## Product Change Notice (PCN)

PCN Number: **PCN-0451204R-01**

Product(s) Affected: **PJ-057AH**

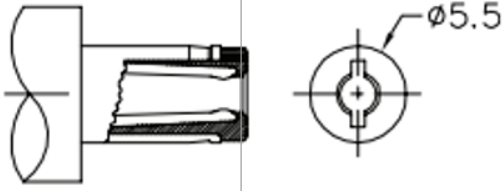
Description of Change: **Minor Housing and footprint differences. Material Change on the housing and terminals. See image Below**

| PREVIOUS CUI DEVICES DETAIL / IMAGE |              |         | NEW CUI DEVICES DETAIL / IMAGE |                 |               |
|                                     | MATERIAL     | PLATING | DESCRIPTION                    | MATERIAL        | PLATING/COLOR |
| center pin                          | copper       | nickel  | center pin                     | brass           | nickel        |
| terminal 1                          | brass        | silver  | terminal 1                     | brass t=0.40    | silver        |
| terminal 2                          | copper alloy | silver  | terminal 2                     | bronze t=0.30   | silver        |
| terminal 3                          | brass        | silver  | terminal 3                     | brass t=0.40    | silver        |
| plastic                             | PBT          |         | cover                          | PA10T (UL94V-0) | black         |
|                                     |              |         | housing                        | PA10T (UL94V-0) | black         |

**MATING PLUG**  
Jack Insertion Depth: 9.15 mm

**MATING PLUG**  
Jack Insertion Depth: 9.45 mm
